**SUBJECT:** SUMMARY OF CONFERENCE CALL MEETING TO DISCUSS OPEN ITEMS AND  
OUTSTANDING REQUESTS FOR ADDITIONAL INFORMATION RESPONSES  
RELATING TO DTE ELECTRIC COMPANY'S FERMI 3 COMBINED LICENSE  
APPLICATION

Subject: **Response to NRC RAI Letter No. 363 Related to ESBWR Design Certification Application – DCD Tier 2 Section 3.8 – Seismic Category I Structures; RAI Number 3.8-94 S05**

**RAI Number 3.8-94 S05**

**Figure 3.8-94(1) Input Motion Spectra and RFB SSI Fundamental Frequencies**

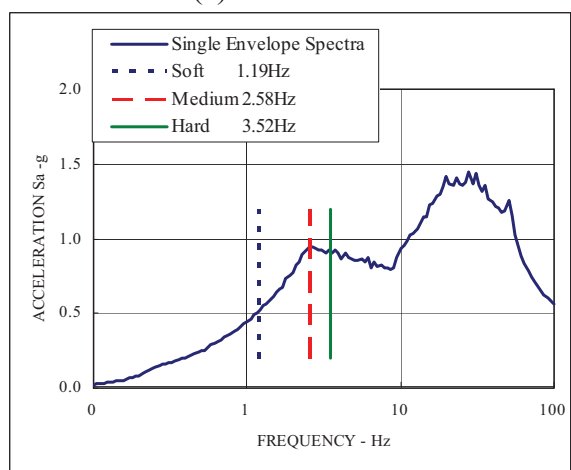
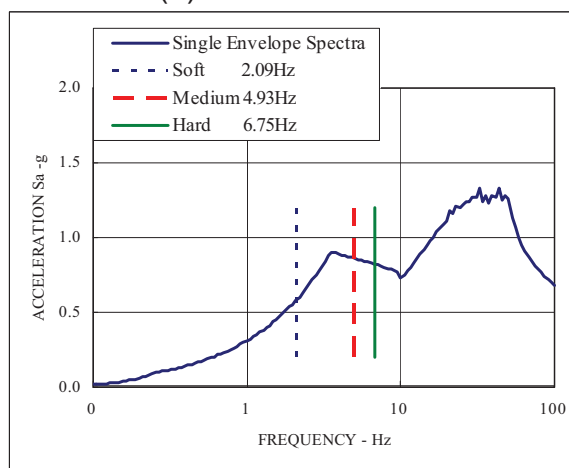
- (2) GEH is requested to explain why it is acceptable to use a linearly interpolated value for the soil bearing capacities between the three sets of values (soft, medium, and hard). Using the information presented in Figure 3.8-94(1) (c) of the response (as an example), this would underpredict the required bearing capacity.*

In accordance with NRC RAI 3.8-94, Supplement 2, Figure 3.8-94(1) (c), the vertical input response spectrum peaks at 3.57 Hz in the frequency range between 2.09 Hz for the soft site and 4.93 Hz for the medium site. This peak vertical frequency is 73% of the vertical SSI fundamental frequency at the medium site.

Applying the same frequency ratio to the horizontal SSI frequencies of the medium site, the horizontal SSI fundamental frequencies for the 3.57 Hz vertical frequency site (termed "intermediate site" hereafter) are found to be 2.14 Hz and 1.87 Hz in the NS and EW directions, respectively. The corresponding spectral accelerations are 0.85g, 0.76g and 0.9g in the NS, EW and vertical directions, respectively, and the corresponding ratios to the medium site spectral accelerations are 0.91, 0.8 and 1.05, as shown in Figure 3.8-94(2).

**Figure 3.8-94(19) FRS (Compared with the DAC3N) – RSW Top Y**

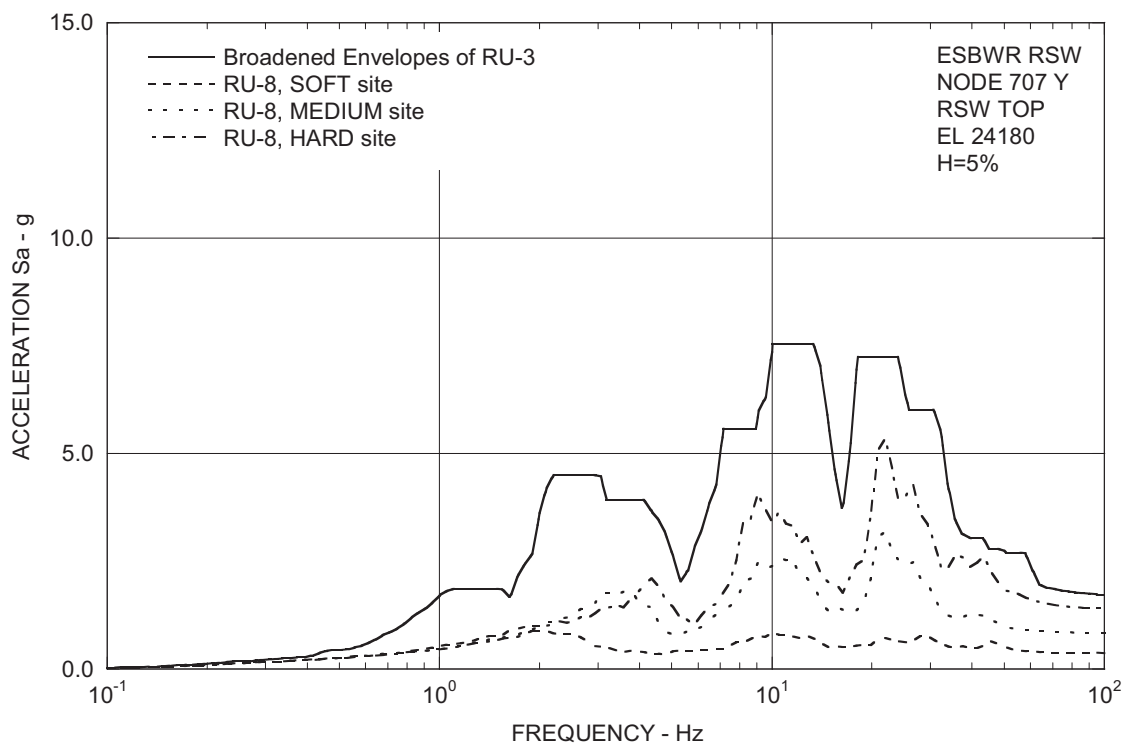
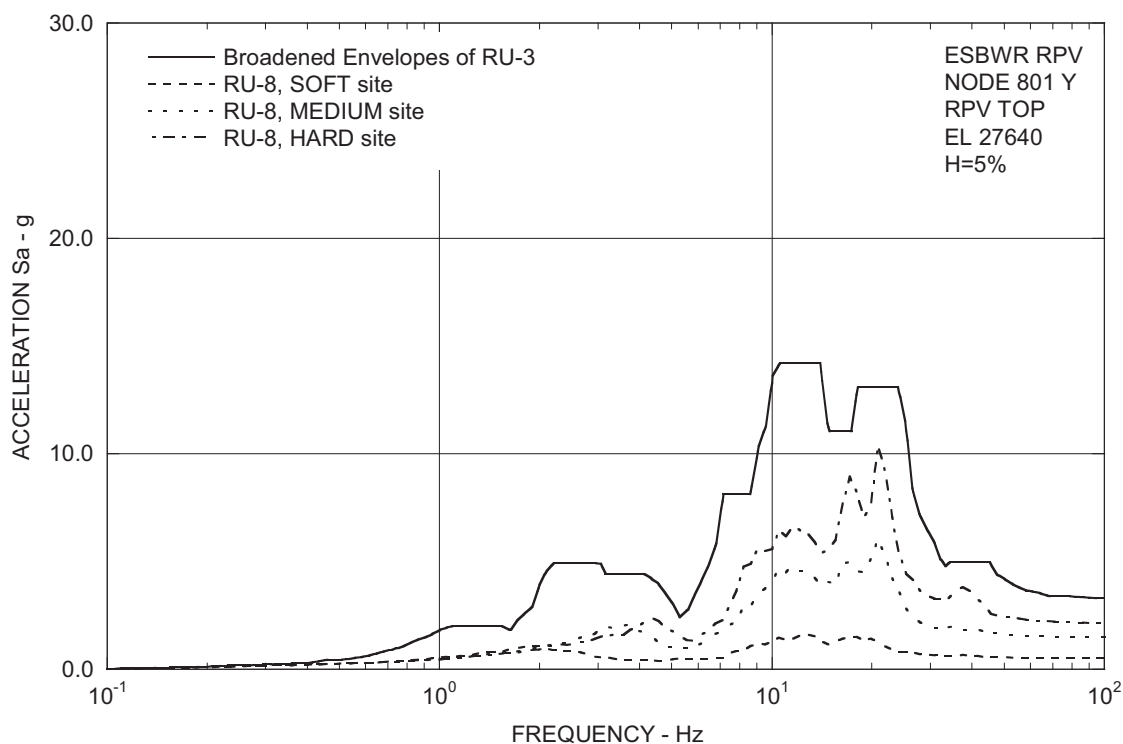
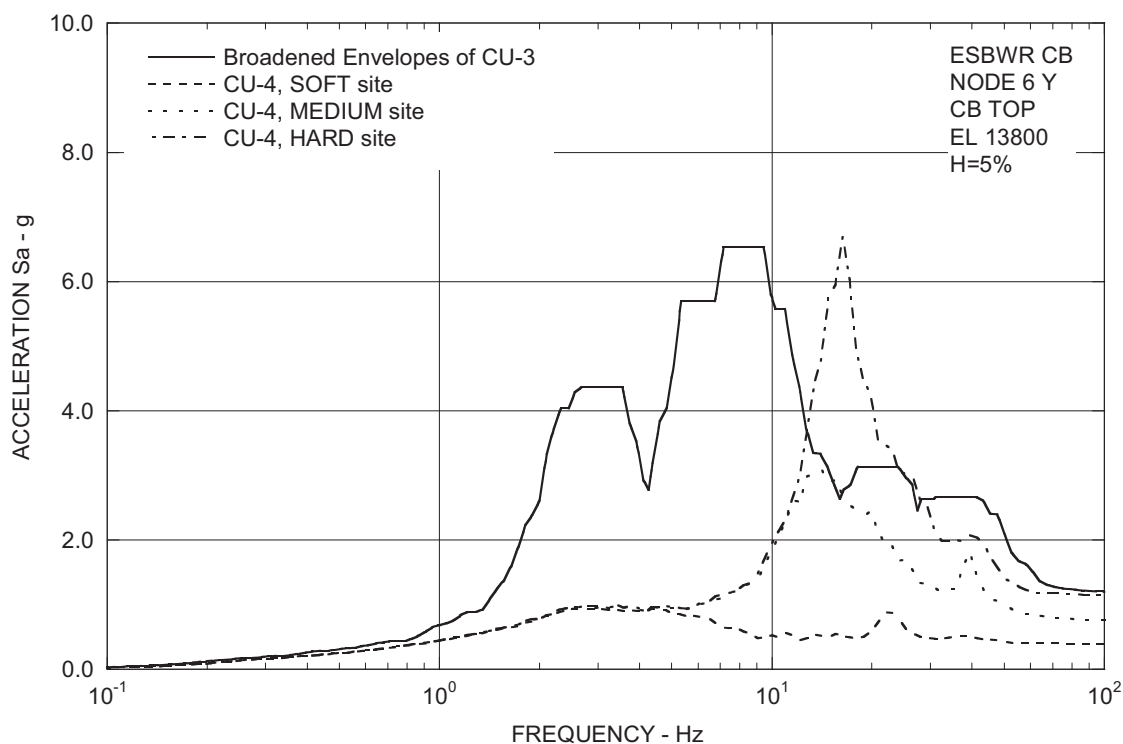
- I) In several of the enveloping floor response spectra (e.g., Figures 3.8-94(19), (20), and (22), the staff noted that “valleys” exist between successive peaks in the low frequency region, up to approximately 5 Hz. If the spectral peaks are influenced by site conditions, it is the staff’s position that these “valleys” should be filled-in to accommodate the expected variability in site shear wave profiles that may be encountered for this generic design. GEH is requested to provide an explanation why these valleys have not been filled-in.*

- I) Sufficient levels of conservatism are already built into the design floor response spectra in the form of enveloping and peak broadening the results of a sufficient number of generic sites under a bounding Certified Seismic Design Response Spectra (CSDRS) ground input motion. To provide additional margins for sites that might have predominant SSI frequencies at the spectral valleys, the spectral valleys of the site enveloping floor response spectra are further filled-in for the generic design floor response spectra. As an example, the original enveloping floor response spectra at the Vent Wall top, which is the same location as shown in Figure 3.8-94(18), is shown in Figure 3.8-94(43) together with its respective enveloping floor response spectra having the spectral valleys filled-in. The site enveloping floor response spectra in DCD Tier 2 Subsection 3A.9.2 will be replaced in Revision 6 with enveloping floor response spectra having the spectral valleys filled-in. DCD Tier 2 Subsections 3A.8.7 and 3A.9.2 will be revised in Revision 6 for clarification with regards to the spectral valleys being filled-in.

**Figure 3.8-94(40) RB/FB Layered Site Soil Case RL-2, Time = 7.810 sec**

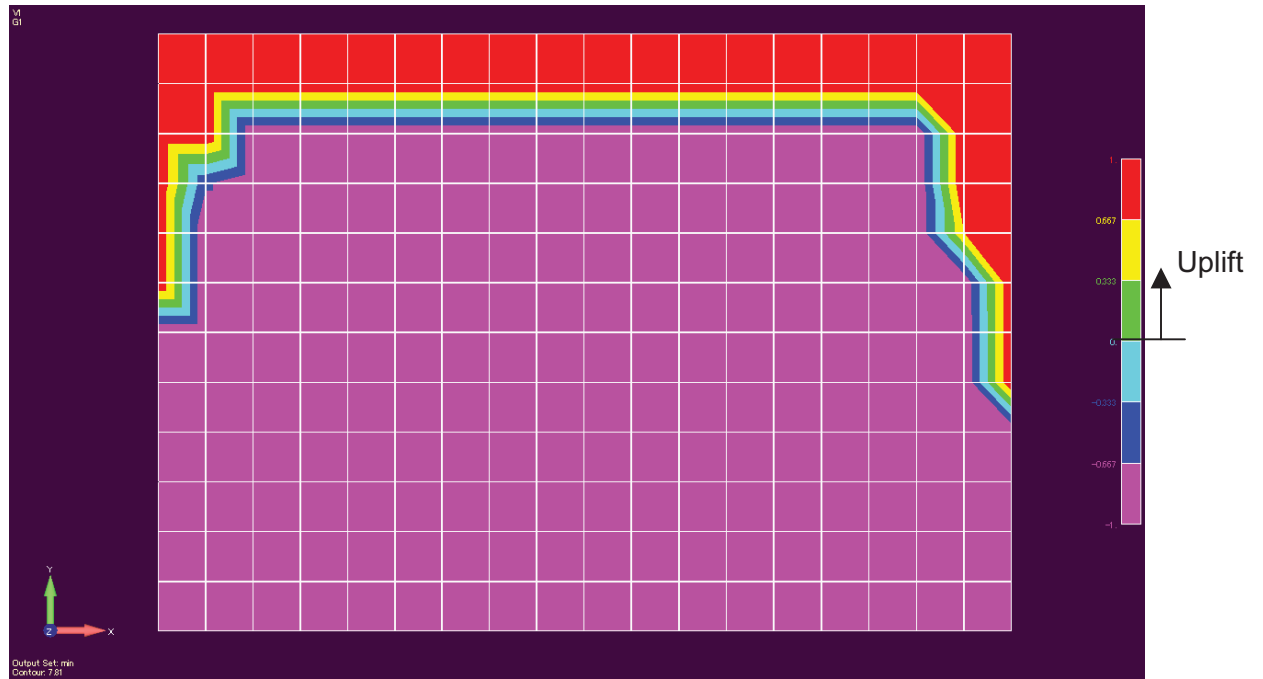
*Lastly, provide the magnitude of the uplift calculated using the EBM so that a comparison can be made with the extent of implied uplift (i.e., tensile basemat/soil interface loads) shown in Figure 3.8-94(40) of the RAI response. The above requested*

The SASSI results for the RB/FB layered site soil Case RL-2 are examined for the extent of maximum uplift when the bearing pressure reaches maximum in combination with dead loads and buoyancy. As shown in Figure 3.8-94(40), the extent of uplift is not extensive and a large portion of the basemat remains in contact with the soil.

**Figure 3.8-94(44) Basemat Configuration and Pressure Distribution**

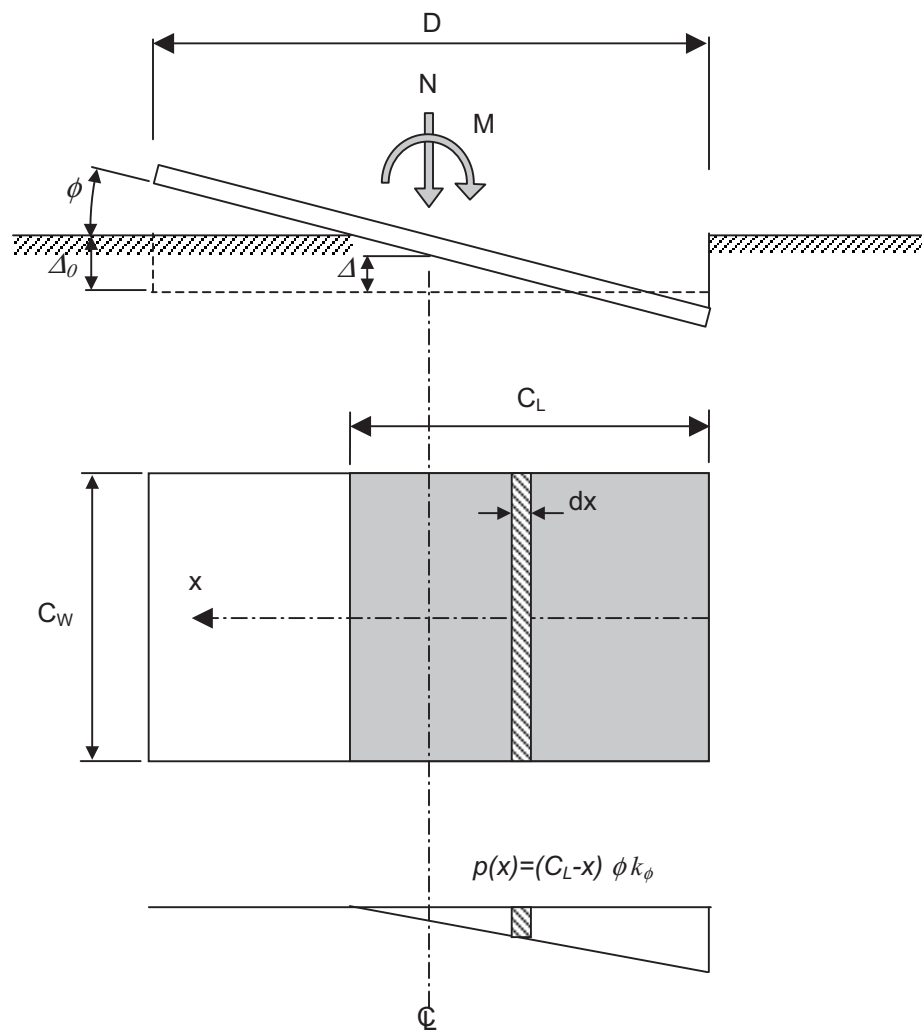
- 1. The formulation presented in the referenced paper is applicable to circular rigid foundations. Provide justification for use of these formulations for the rectangular foundations for ESBWR. Otherwise, if a new set of formulations were derived for the rectangular foundations at ESBWR, provide the basis for these new formulations.*

Figure 3.8-94(44) shows the configuration of a rigid rectangular basemat in the uplifted position. The basemat is considered to be supported by a set of uniformly distributed compression (no tension) vertical soil springs having stiffness  $k_\phi$  per unit area, which are determined by the following:

Referring to Figure 3.8-94(44), the foundation vertical force  $N$  and the overturning moment  $M$  in the uplifted position can be related to soil pressure  $p(x)$  and the foundation contact length  $C_L$ .

**Figure 3.8-94(45) Modified Energy Balance Method**

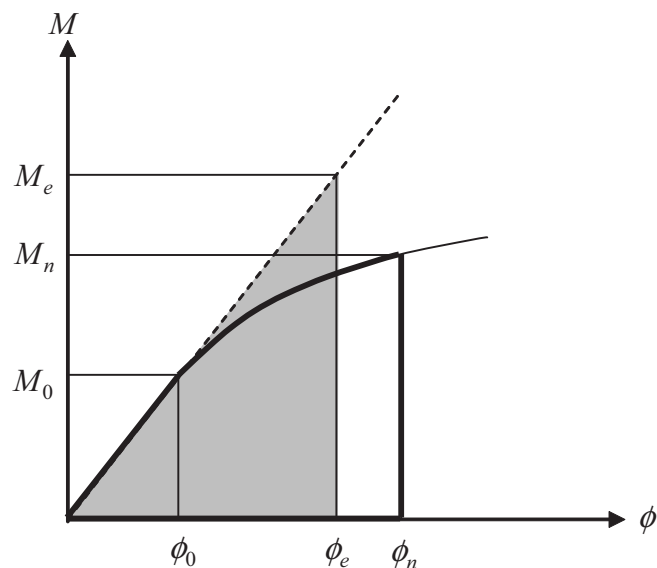
*Item B in the RAI 3.8-94 S04 response provided only a one sentence description of the Energy Balance Method (EBM) and identified the source for this method which is a paper presented in the 6th SMiRT conference. A review of this paper has led to the need for GEH to address some items:*

The “Energy Balance Method” stipulates that the above non-linear rocking rotation  $\phi_n$  is determined so that the soil strain energy is equal between  $U_e$  in (6) and  $U_n$  in (7) as illustrated in Figure 3.8-94(45). Then, the soil pressure is calculated as the maximum stress at the edge as follows:

- (2) The above method for improving the rocking rotation and soil pressure is called the “Modified Energy Balance Method (MEB)” in the referenced paper and has been utilized in the ESBWR soil bearing pressure calculations.

**Figure 3.8-94(46) Soil Pressures due to Moments in Two Directions**

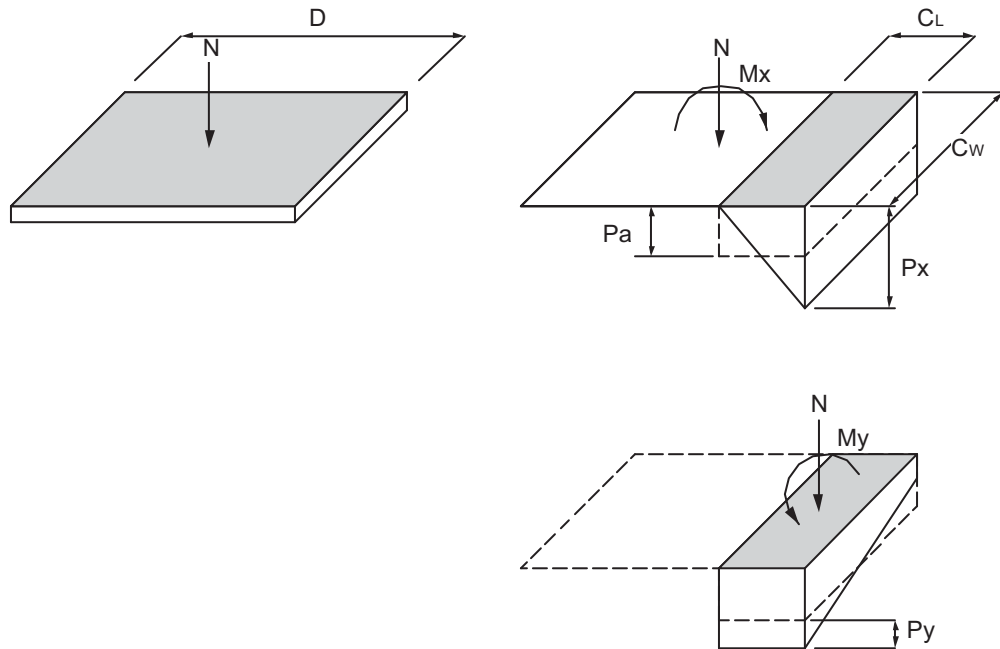
- 3. Confirm that the "Contact Width – CW" used in the formulations for bending about the other (perpendicular) horizontal axis corresponds to the full width of the foundation. If this is the case, then explain why the full width is utilized. Has it been determined that no uplift is possible for rotation about the other horizontal axis or that the uplift about both axes do not occur at the same time? The staff notes that if there is uplift possible for rotation about the other horizontal axis, this might cause higher soil bearing pressures than those calculated in the RAI response.*

- (3) To account for potential uplift due to rotation about the other horizontal axis, two separate cases, a)  $M_x$  using MEB together with  $M_y$  with full width  $C_W$  and b)  $M_y$  using MEB together with  $M_x$  with full width  $C_W$ , were considered as illustrated Figure 3.8-94(46). The final soil bearing pressure is the envelope results of the two cases.
